## RMA/2023/2046 – 33 Dublin Street – Urban Design Assessment

David Hattam, 23 February 2024

**Above: View of application site from the south east**

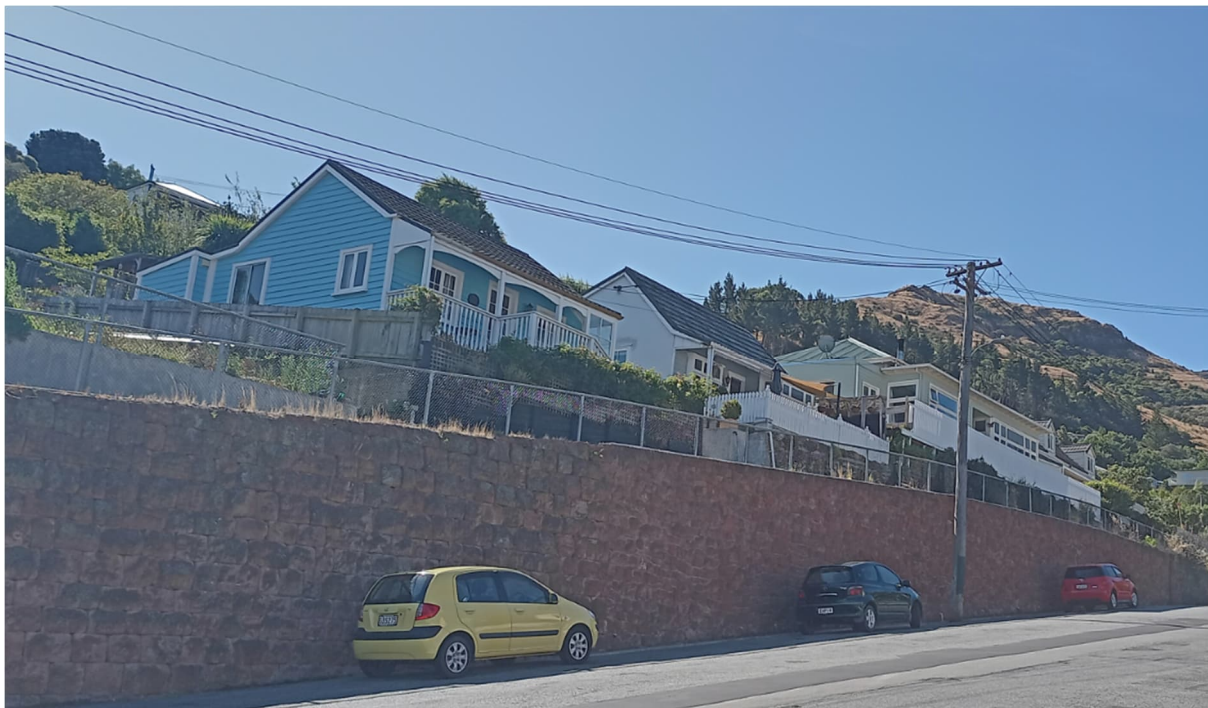
The house sits within a cluster that is visible above the wall, in particular from down slope on Dublin Street and across the street. This group of elevated houses have a reasonably consistent pattern and form a coherent group, which is visible from various points in the townscape, notably to the south and east.

The removal of the house would diminish the coherence of the area because it would interrupt the rhythm and pattern of houses on top of the wall. The row of houses is prominent from some locations. It is visible at close distances (such as across the street) and also more widely in the townscape (due to the topography it is intermittently visible from medium distances such as Canterbury Street). From these intermediate distances, the loss of the house will be quite noticeable and the coherence of the built form will be reduced.
